February 12, 2024

RE: 14 Tallwoods Road
Christian Jungers & Michelle Starr
14 Tallwoods
Tax ID – Section 107.02, Block 1, Lot 17

This office is pleased to provide updated plans in support of the Christian Jungers and Michelle Starr Site Plan, Wetland, Steep Slope and Tree Removal approvals related to the proposed swimming pool at 14 Tallwoods Road. Plans have been updated and supplemental information provided to address the conditions of the Resolution of Approval. Plans and comments have been addressed as follows:

2000 GALLON HOLDING TANK DETAIL NOT TO SCALE 16

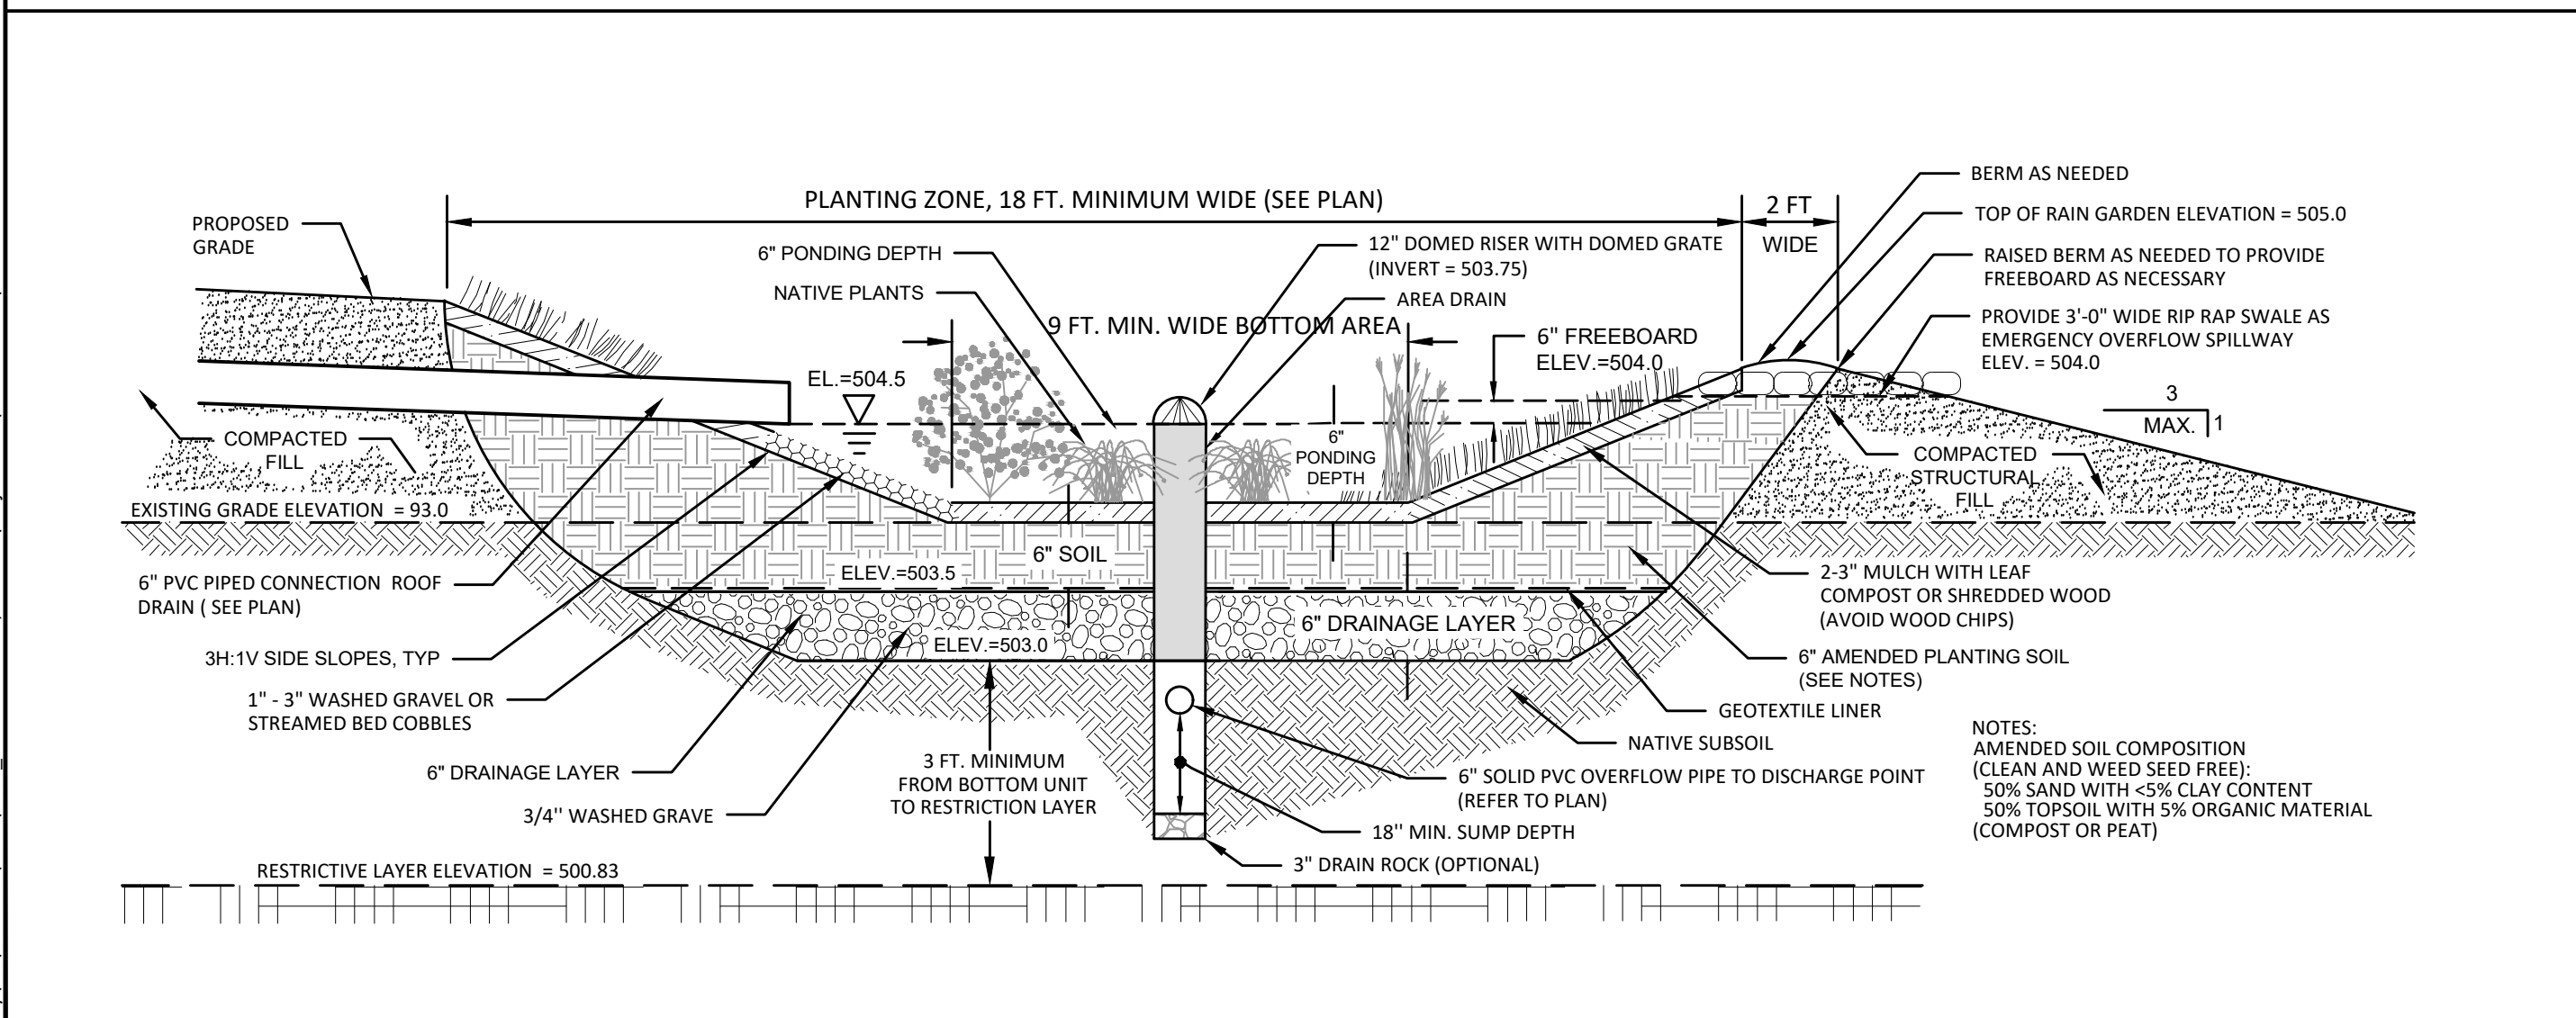
3. *The applicant shall prepare a stormwater mitigation plan which mitigates the stormwater runoff impacts from the proposed improvement to the satisfaction of the Town Engineer. The stormwater*

mitigation plan shall be accompanied by stormwater design calculations which mitigates peak flows during the 25-year, 24-hours design storm.

Response: Due to the constraints on the site and limited area available for stormwater mitigation, the plan offers two (2) practices to mitigate stormwater runoff; a 2,000 gallon holding tank for pool drawdown and site runoff and a rain garden. Two (2) roof drains within the project area currently discharge runoff directly to the surface. The plan proposes that stormwater runoff from a portion of the existing dwelling's roof, comparable in area to the proposed improvements, will be redirected to the rain garden. The second roof drain will be directed to the holding tank, effectively disconnecting the roof runoff from the discharge points. High level overflows will then be connected to the existing outlet pipes. The plan has been updated to reflect pipe connections directed to both the holding tank and the rain garden.

WETLAND MITIGATION PLAN
 FOR
THE STARR RESIDENCE
 14 TALLWOODS ROAD
 NORTH CASTLE, N.Y.

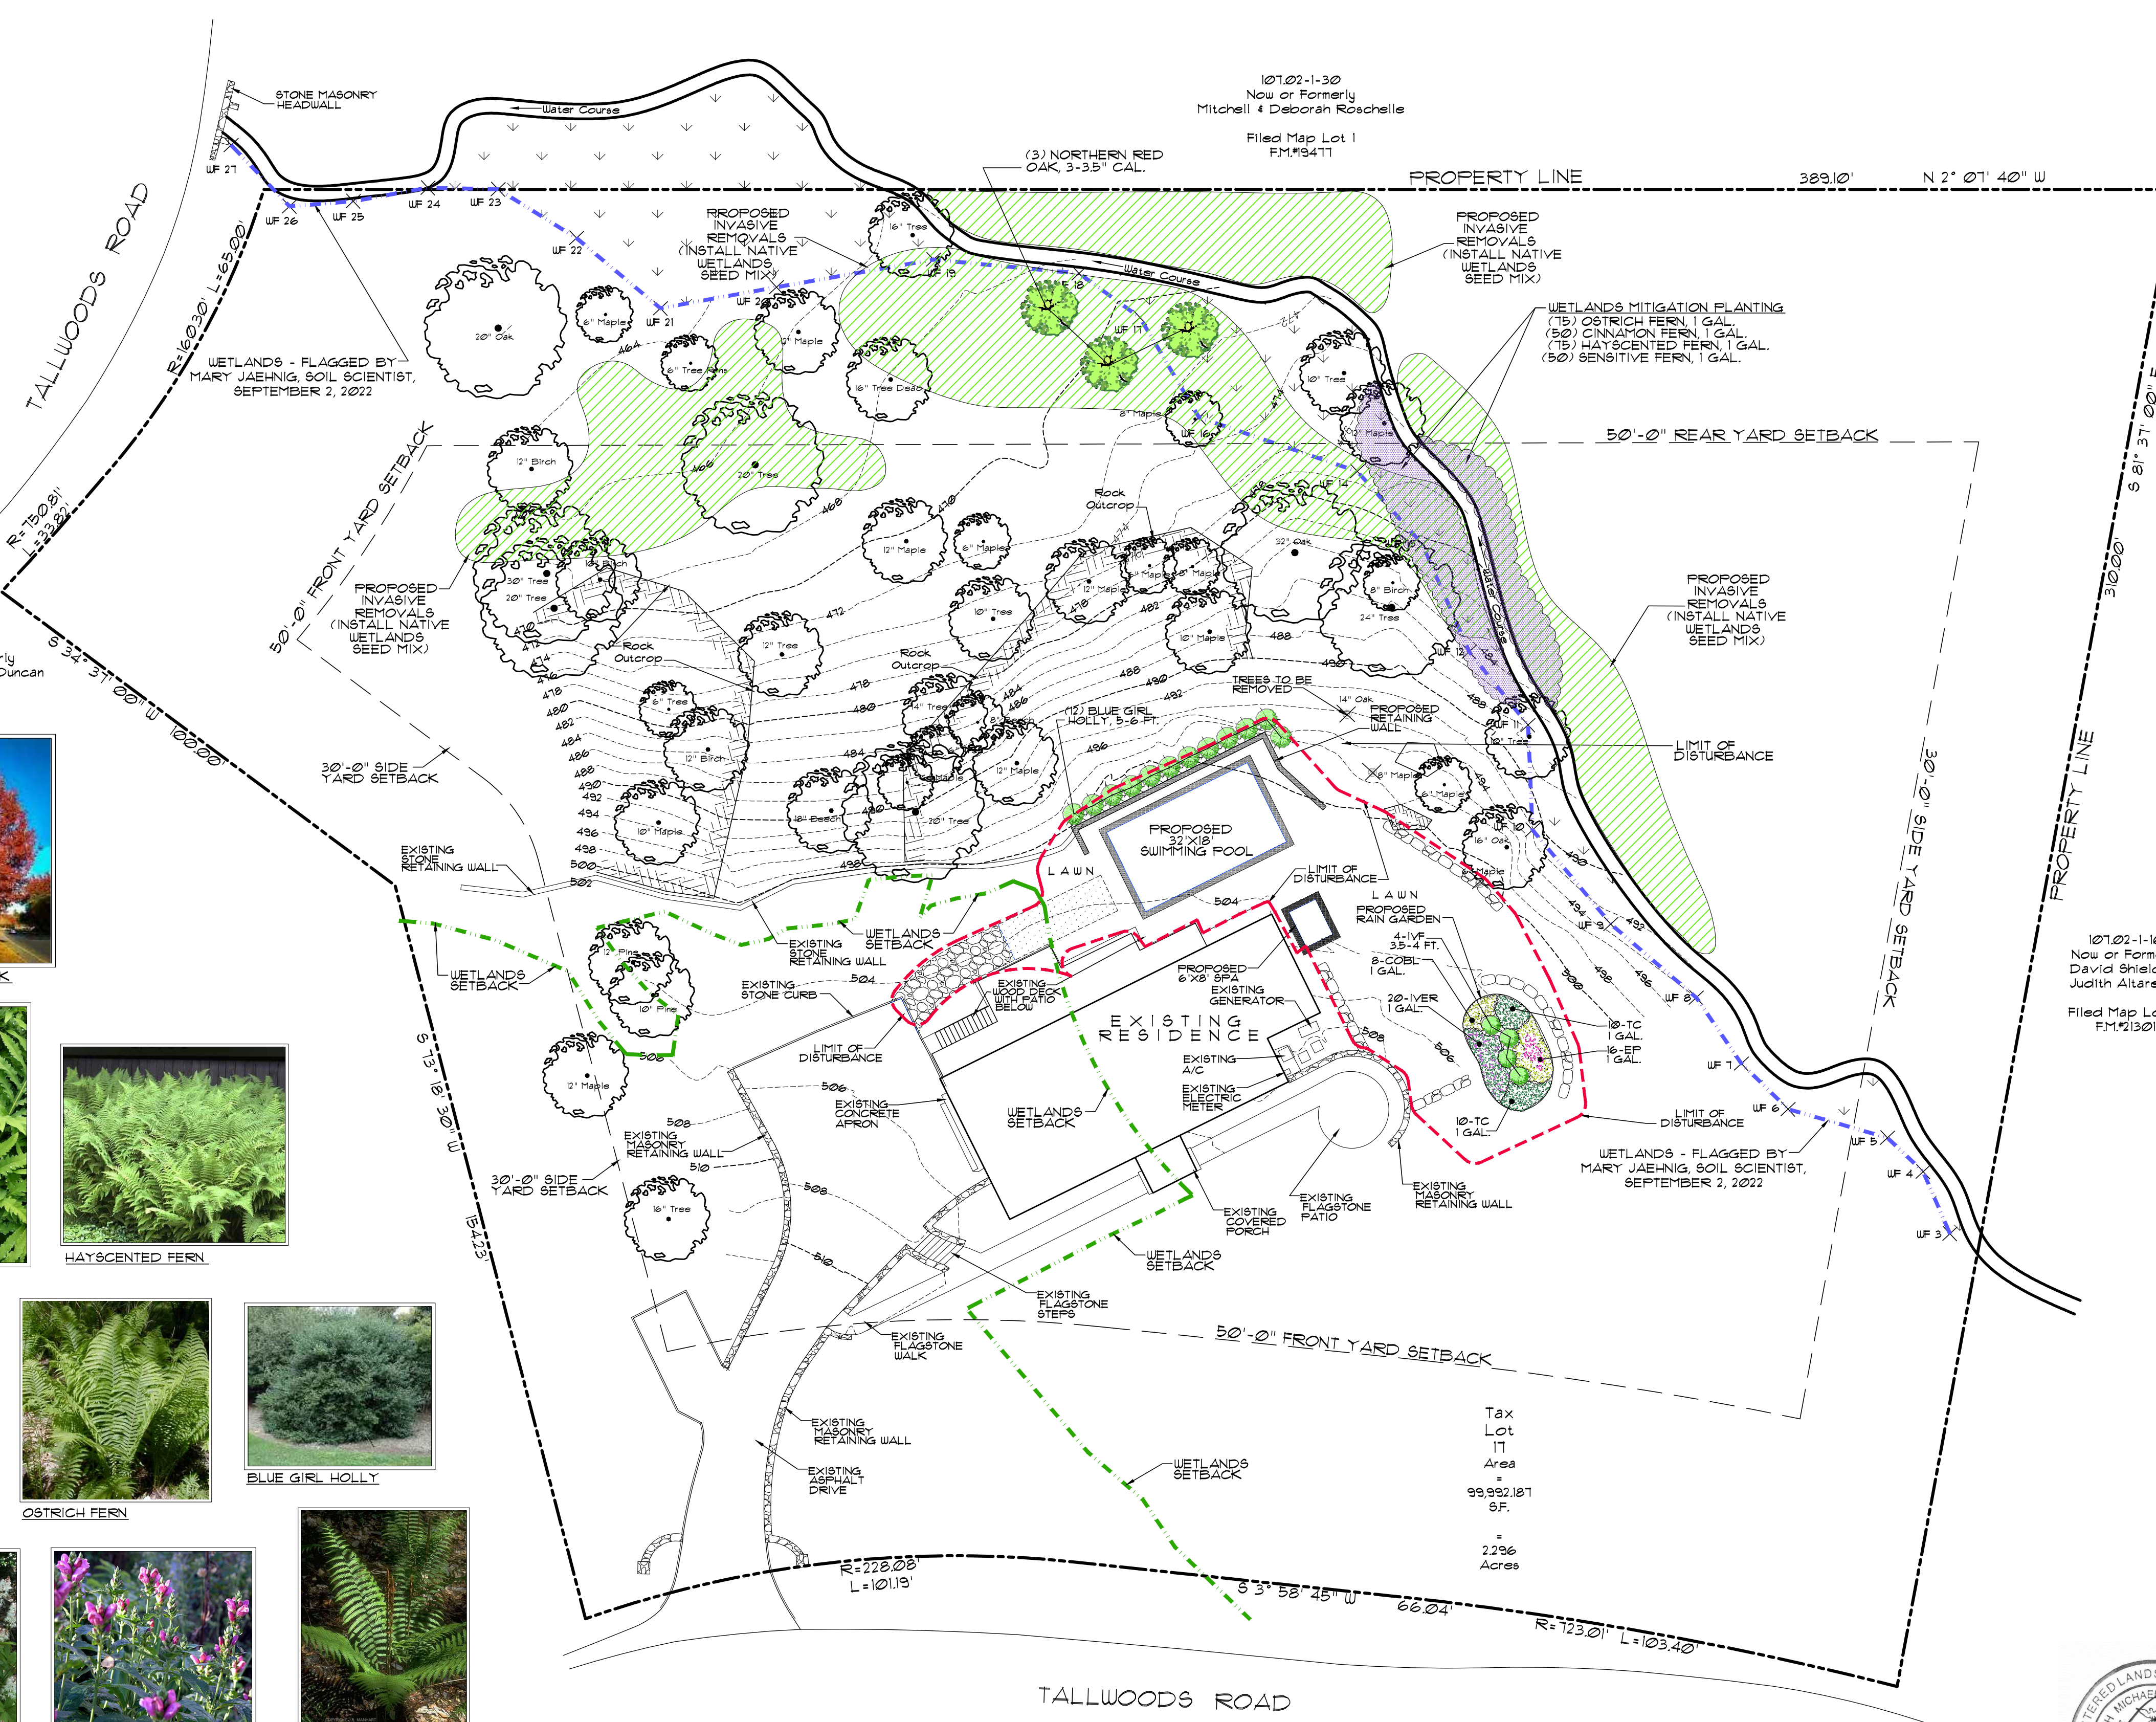
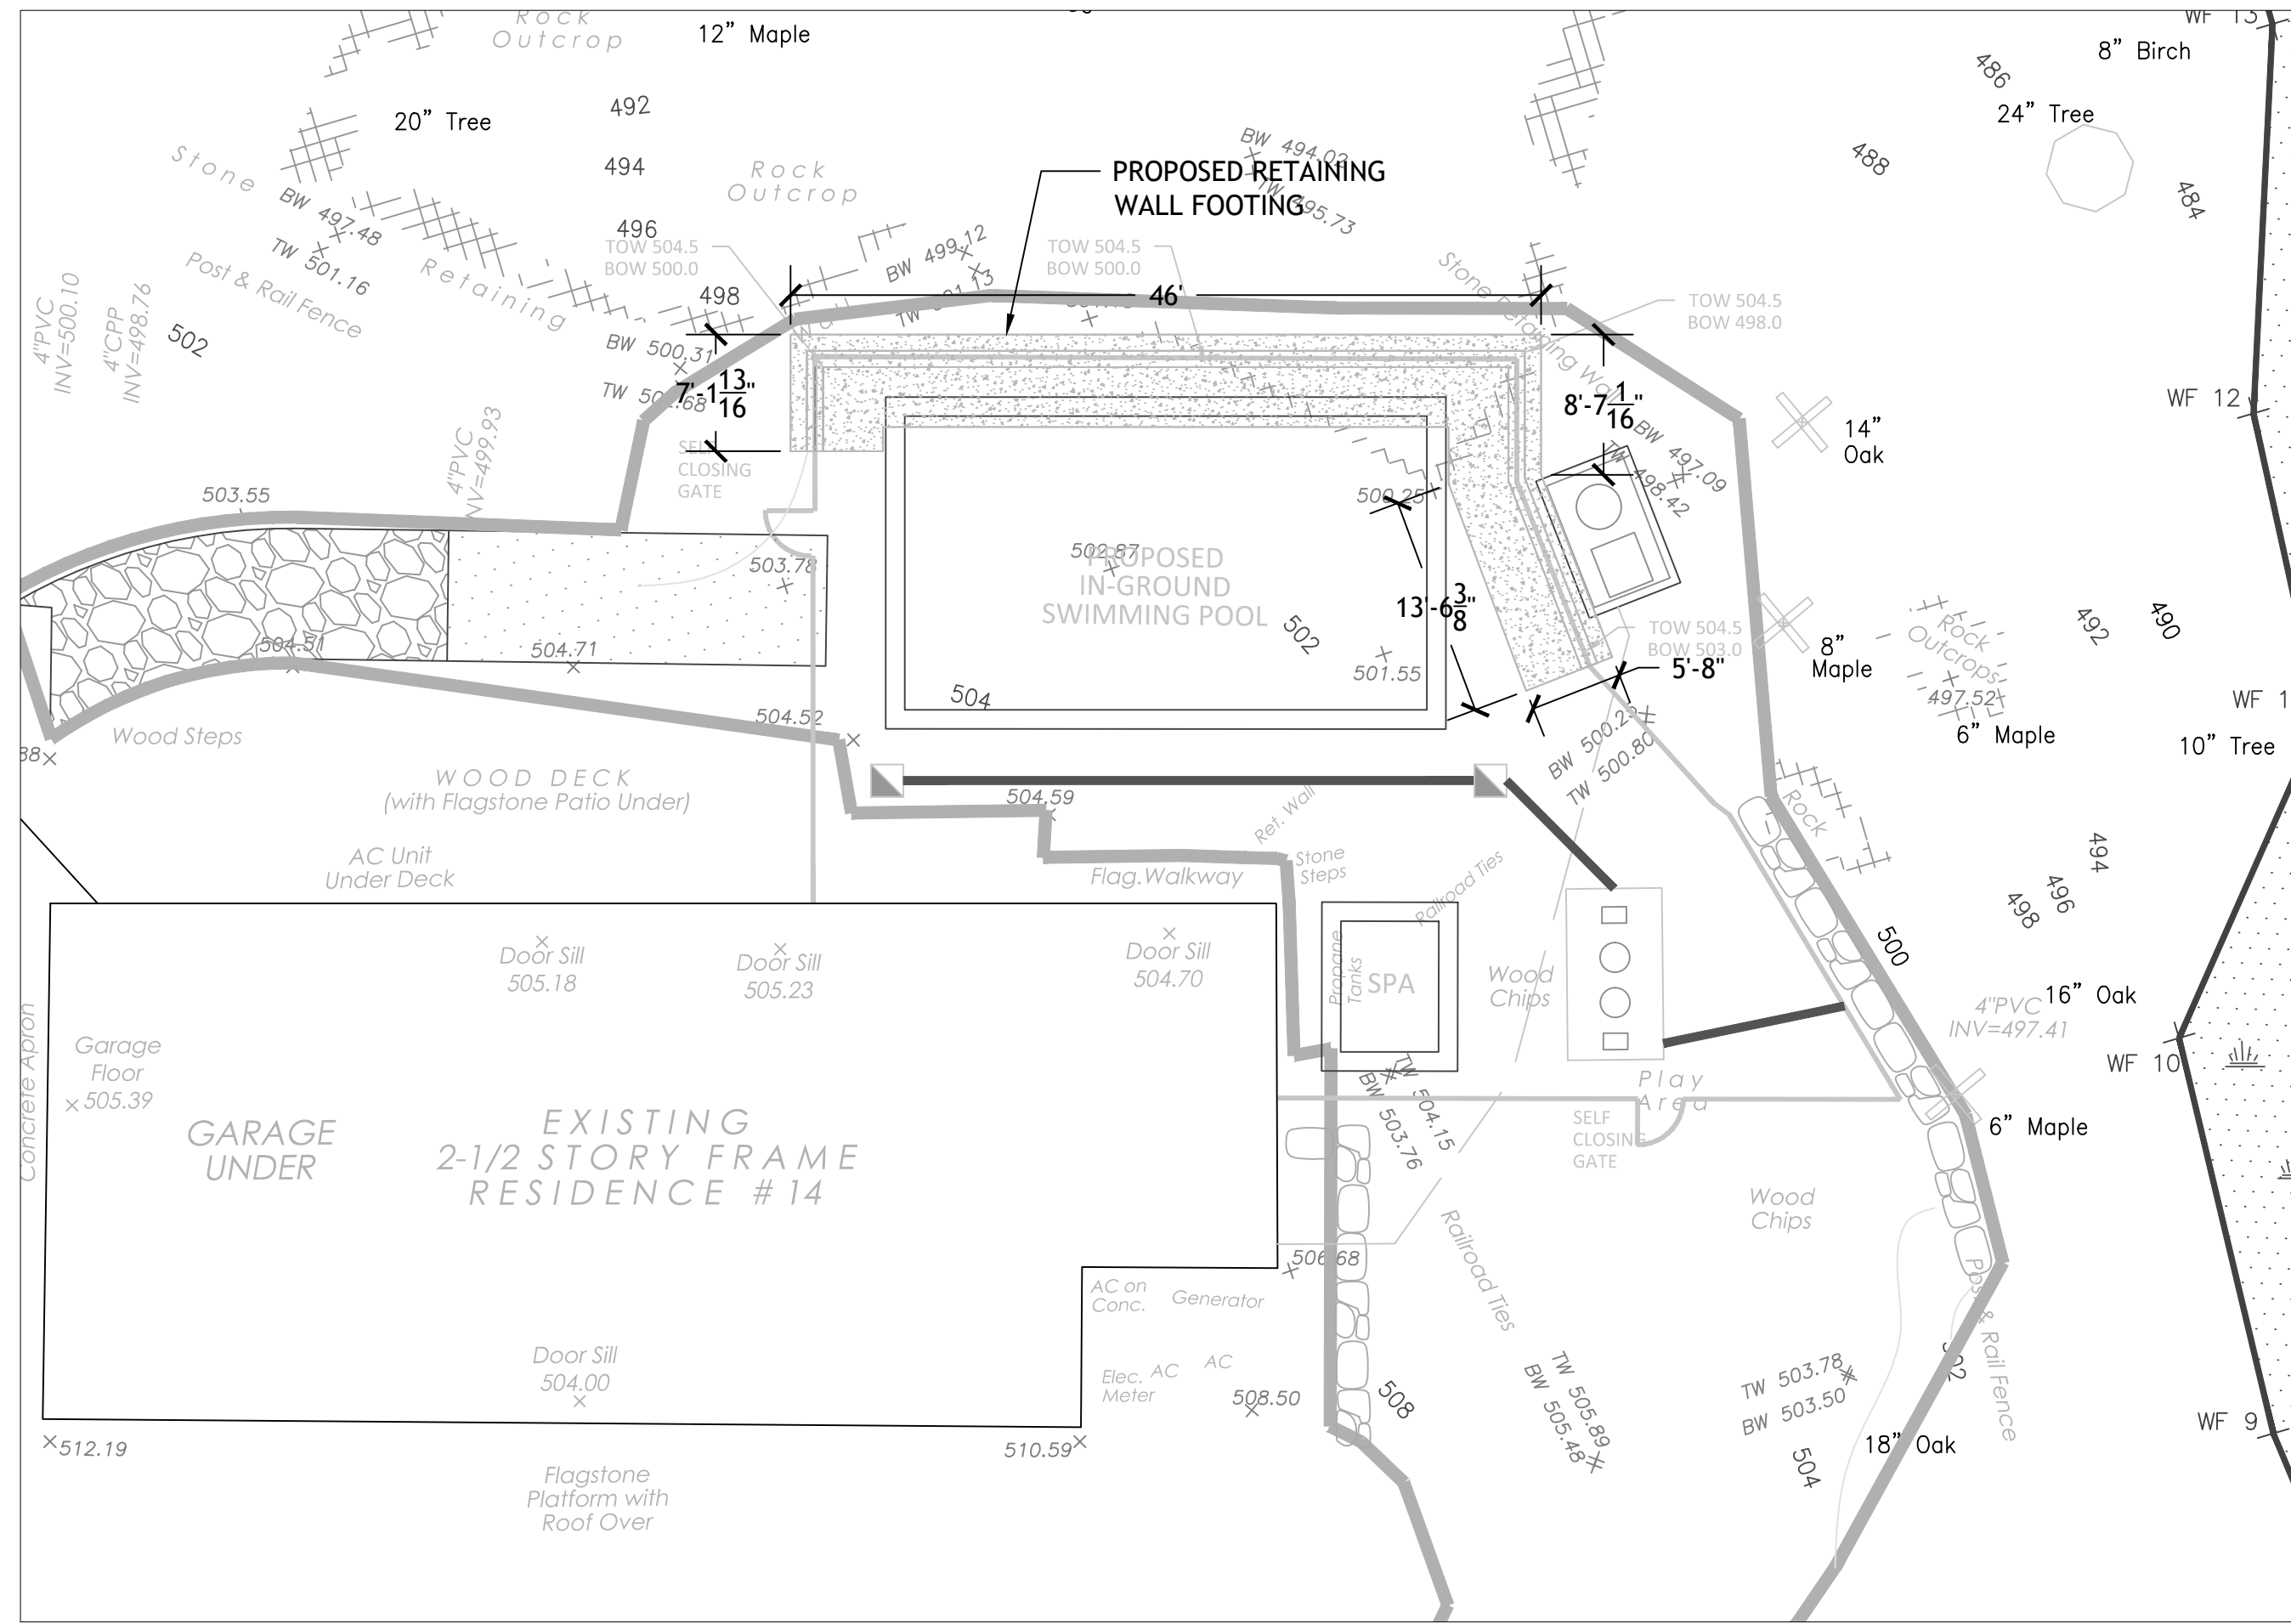
4. *As required by Town Code, the applicant shall provide a long-term monitoring and maintenance plan for the proposed wetland mitigation for a period of at least five (5) years to the satisfaction of the Town Engineer. The plan shall require an 85% survival rate. The Town Engineer will provide standard conditions for the long-term monitoring and maintenance plan to be included on the Site Landscaping and Wetland Mitigation Plan.*

Response: A long term monitoring and maintenance plan for the proposed wetland mitigation, for a period of five (5) years has been prepared and is attached for review. Any additional conditions for the long-term monitoring and maintenance plan will be included on the Wetland Mitigation Plan.
